United States Patent and Trademark Office

APPLICATION NO.	FILING DATE	FIRST NAMED INVENTOR	ATTORNEY DOCKET NO.	CONFIRMATION NO.	
10/774,400	02/10/2004	Benjamin Arnette Lagrange	839-1383	9775	
30024 7	590 11/24/2006		EXAMINER		
	ANDERHYE P.C.	VERDIER, CHRISTOPHER M			
901 NORTH G ARLINGTON.	SLEBE ROAD, 11TH FLO VA 22203	OR	. ART UNIT	PAPER NUMBER	
,,,,,,,,,,,,,,,,,,,,,,,,,,,,,,,,,,,,,,,	,		3745		
			DATE MAIL ED. 11/24/200

<i>P</i>	Application No. Applicant(s)					
Office Action Summary			10/774,400	LAGRANGE ET A	LAGRANGE ET AL.			
			xaminer	Art Unit				
	·	0	Christopher Verdier	3745				
Period fo	The MAILING DATE of this commun or Reply	ication appea	rs on the cover sheet	with the correspondence ac	idress			
WHIC - Exte after - If NC - Failu Any	ORTENED STATUTORY PERIOD F CHEVER IS LONGER, FROM THE M nsions of time may be available under the provisions SIX (6) MONTHS from the mailing date of this come o period for reply is specified above, the maximum st are to reply within the set or extended period for reply reply received by the Office later than three months ed patent term adjustment. See 37 CFR 1.704(b).	MAILING DAT s of 37 CFR 1.136(a nunication. atutory period will a v wi

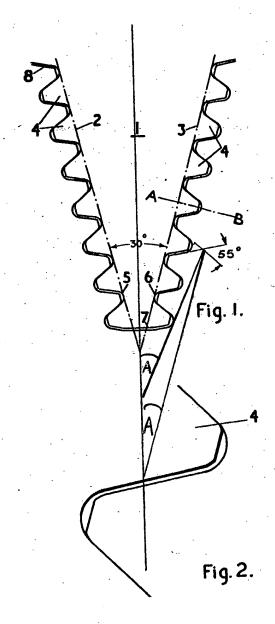
Claims 29-30 are rejected under 35 U.S.C. 102(b) as being anticipated by United Kingdom Patent 677,142. Note the unnumbered bucket for insertion into an unnumbered wheelpost of an unnumbered turbine rotor in a first or second stage of a turbine, the bucket being formed from interleaved unnumbered fillets and tangs 4 which complement interleaved fillets and tangs formed in the wheelpost, with an angle formed by tangent lines along the uppermost tangs on either side of a center line bisecting each of the buckets being 41.564° and the bottom most tang does not lie along the tangent lines forming the angle. The bucket has three interleaved tangs and fillets. Note that the claims do not specifically recite the particular geometry of the intersection of the angle formed by tangent lines along uppermost tangs on either side of a center line bisecting each of the buckets. That is, a line drawn from the intersection of the angle A formed by tangent lines to the upper most tangs on each side of a center line bisecting each of the buckets may be selectively drawn such that it intersects the center line (at a portion of the center line remote from the blade root) and forms the

aforementioned 41.564 degrees, since the location where the drawn line intersects the center line is an arbitrary location. See the annotated figure below.

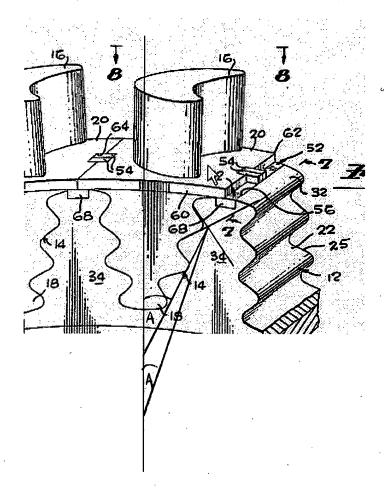
Claims 29-32 and 34-36 are rejected under 35 U.S.C. 102(b) as being anticipated by Webb 3,202,398. Note the bucket 16 for insertion into a wheelpost 34 of a turbine rotor 10 in a first or second stage of a turbine, the bucket being formed from interleaved unnumbered fillets

and tangs which complement interleaved fillets and tangs (near 22) formed in the wheelpost, with an angle formed by tangent lines along the uppermost tangs on either side of a center line bisecting each of the buckets being 41.564° and the bottom most tang does not lie along the tangent lines forming the angle. The bucket has three interleaved tangs and fillets. The bucket has a bottom tang 18 formed from curved surfaces having more than one radius of curvature. The bucket further includes at least one straight surface (the leading and trailing edges). The bucket has an upper tang formed from curved surfaces having more than one radius of curvature. Note that the claims do not specifically recite the particular geometry of the intersection of the angle formed by tangent lines along uppermost tangs on either side of a center line bisecting each of the buckets. That is, a line drawn from the intersection of the angle A formed by tangent lines to the upper most tangs on each side of a center line bisecting each of the buckets may be selectively drawn such that it intersects the center line (at a portion of the center line remote from the blade root) and forms the aforementioned 41.564 degrees, since the location where the drawn line intersects the center line is an arbitrary location. See the annotated figure below.
